**The Woodlands Off-Site Sanitary Lift Station, Force Main & Gravity Sewer Line A (RFCSP)**

**Solicitation Number: CO-00682**

**ADDENDUM 3**

**November 15, 2023**

SHEET NO. **E-3**

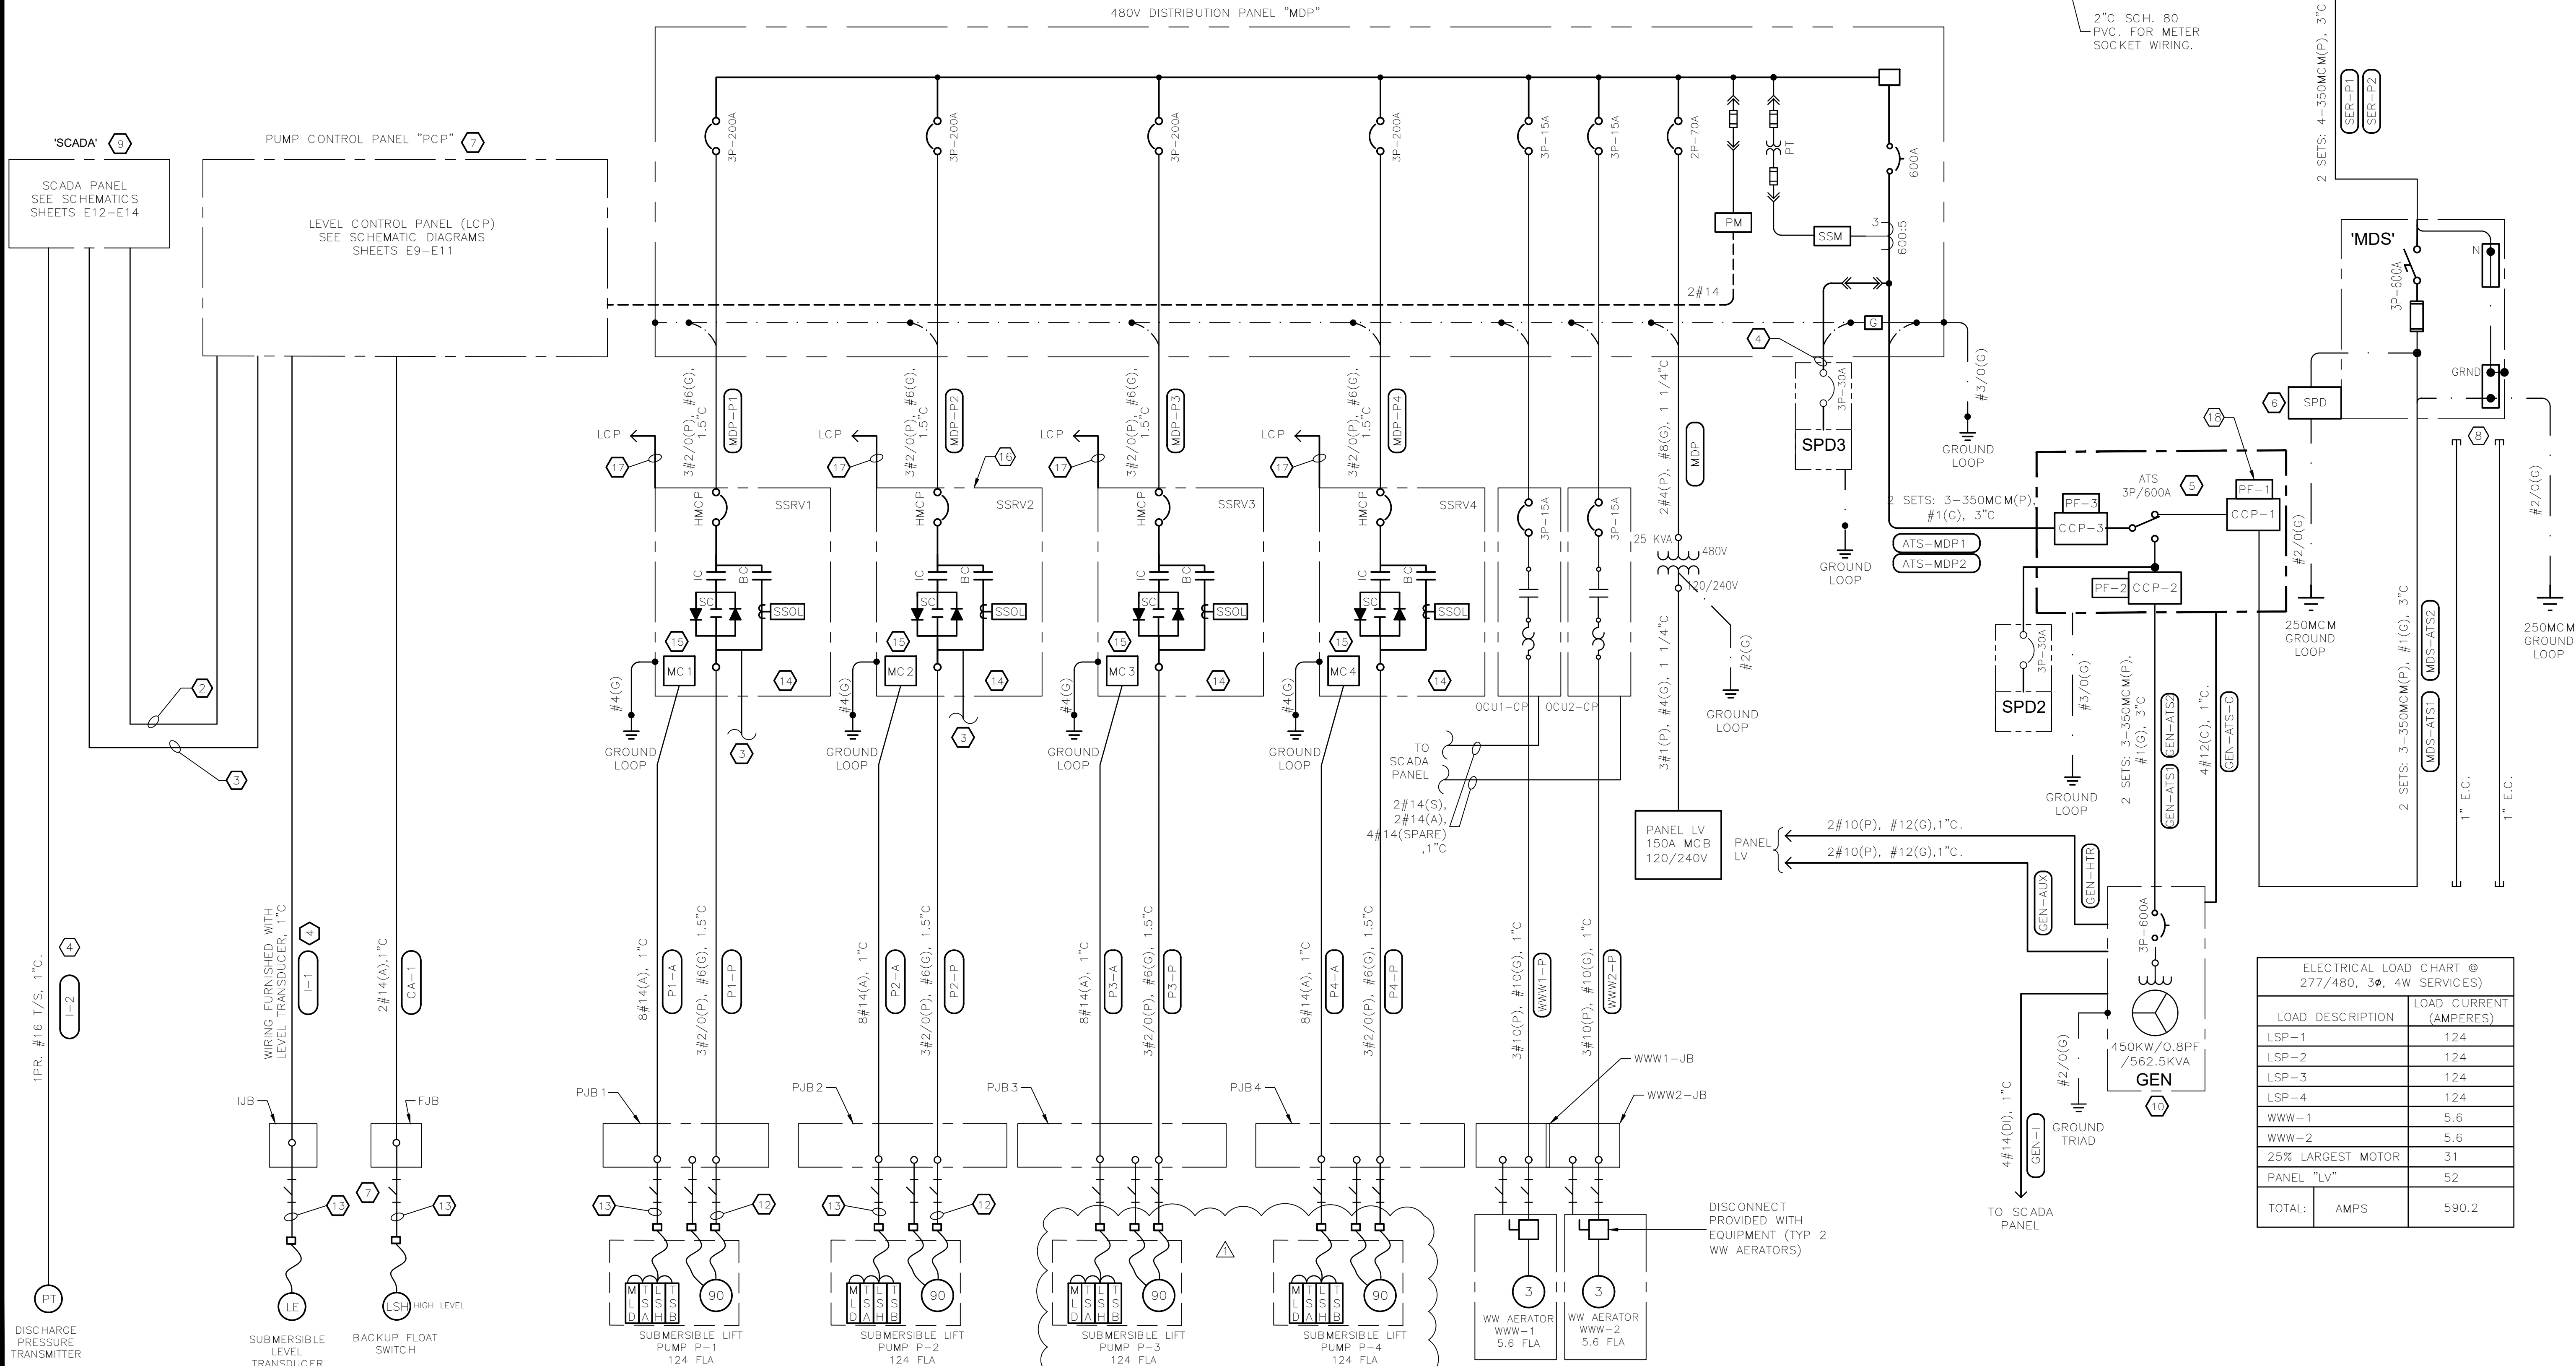
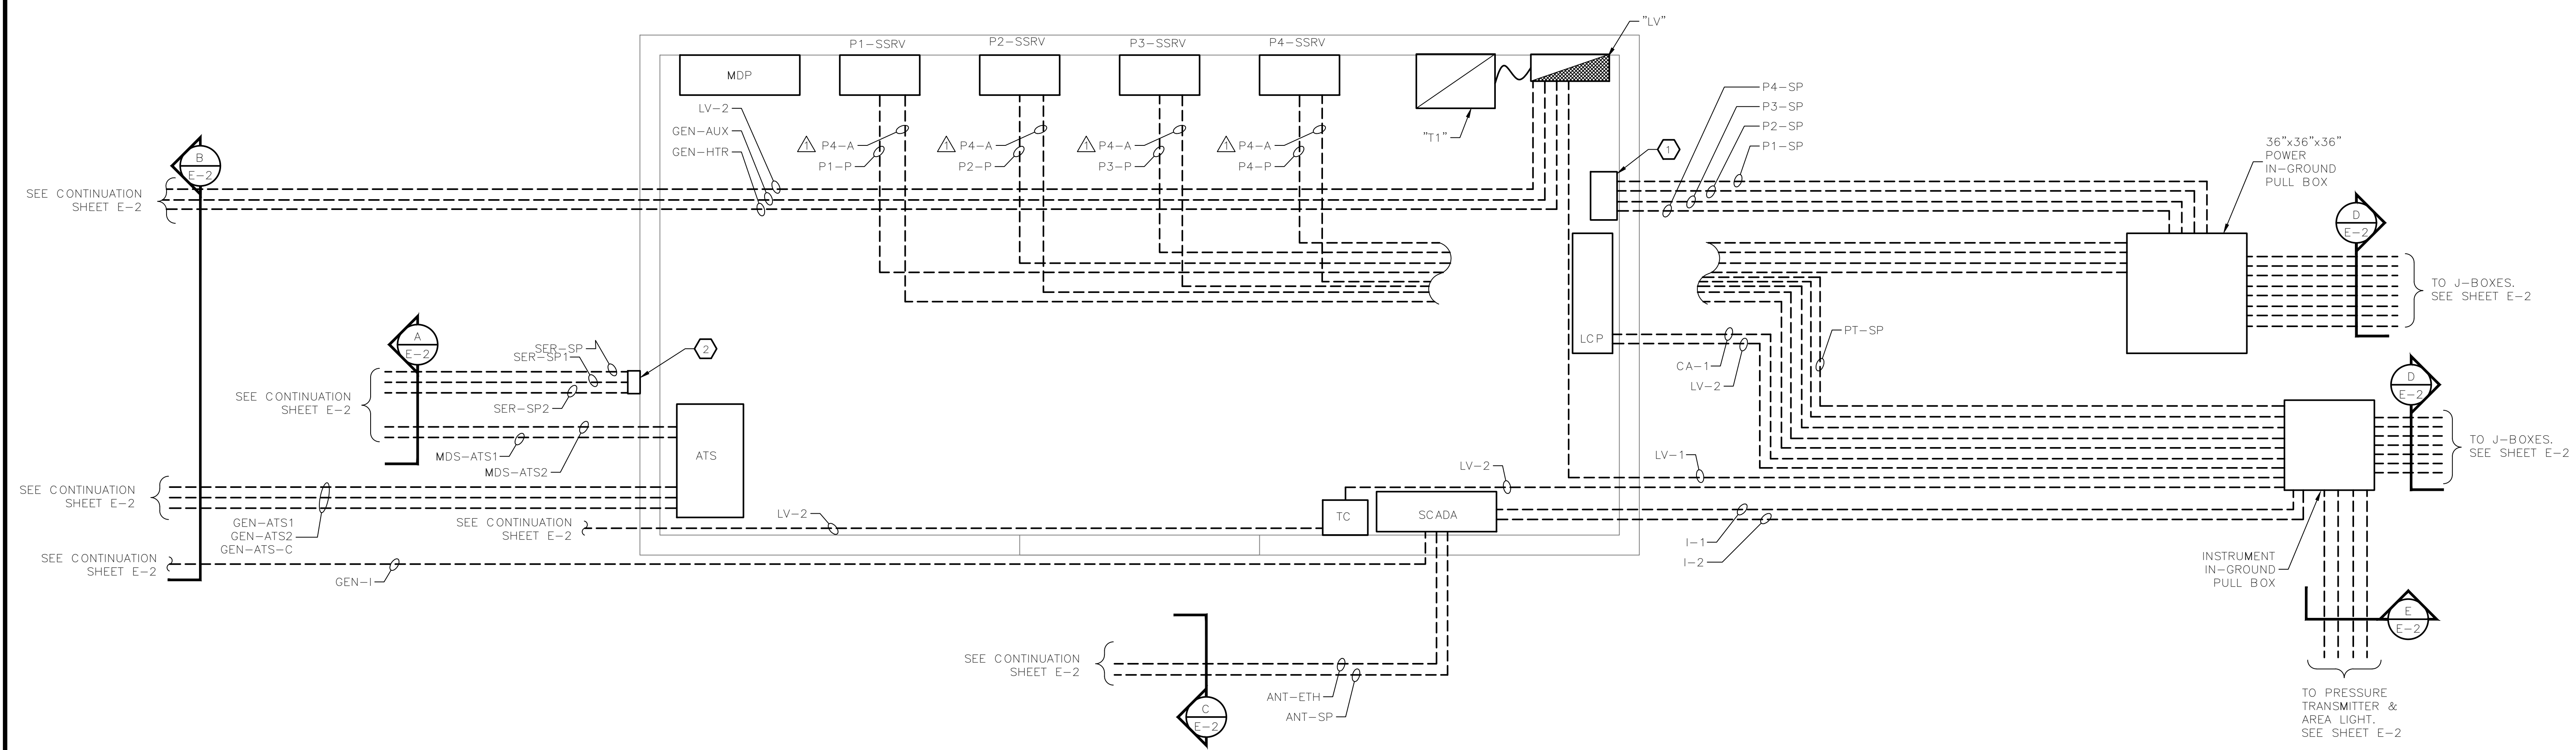
3. **Question:** One Line diagram E-3 indicates Lift Pump P-3 and P-4 as “Future”, whereas all other bid documents seem to indicate these are to be included in this scope of work. Please clarify.

8. **Question:** Specification Section 16461 calls for a Self Contained Unit Power Center (MPZ), Sheet E-3 One-line diagram has Keynote #11 for a MPZ and refers to E-13, Keynote #11 does

not show on the one-line diagram, sheet E-13 shows SCADA Panel Schematics. Please clarify if MPZ is required for the project or not.

**Answer:** *Lift Station pumps P-3 and P-4 are not future and will be installed as part of this contract. See Changes to the Plans #1. A revised sheet E-3 is included with this addendum.*

**Answer:** *An MPZ is not required. Panelboard will be used instead. Sheet E-16 shows panelboard schedule. See Changes to the Plans #1. Sheet E-3 has been revised to remove reference to an MPZ.*
